Subject: 1980, ISX15 CM2350 Fuel Pump Tappet -EDS Guided -ATC-Multiple Customer

Number: Atc1980 **Date:** 03-May-2019

This is to revise and replace ATC 1980-A, dated 23-Oct-18. This revision is to:

Figure 1: Tappet guide plug, floating pin, and the tappet roller with guide slot.

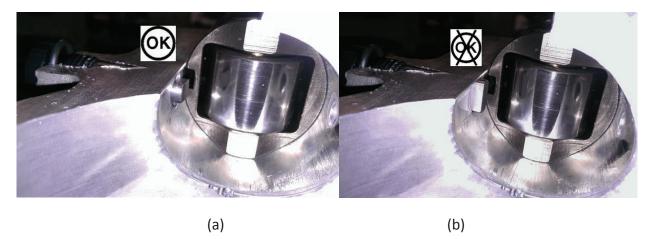
The tappet guide pin is a floating pin and plug design, as shown in Figure 1 below. The floating pin has a rectangular end that engages the groove on the tappet. Refer to Figures 2 and 3. The pin can be rotated by hand. Be certain the pin engages the tappet properly before installing the fuel pump head.

NOTE: Warning! The tappet guide pins may rotate during the removal of the tappet. The tappet cannot be correctly installed if the tappet guide pin is out of position. Please refer to Attachment B for the proper orientation of the tappet guide pin.
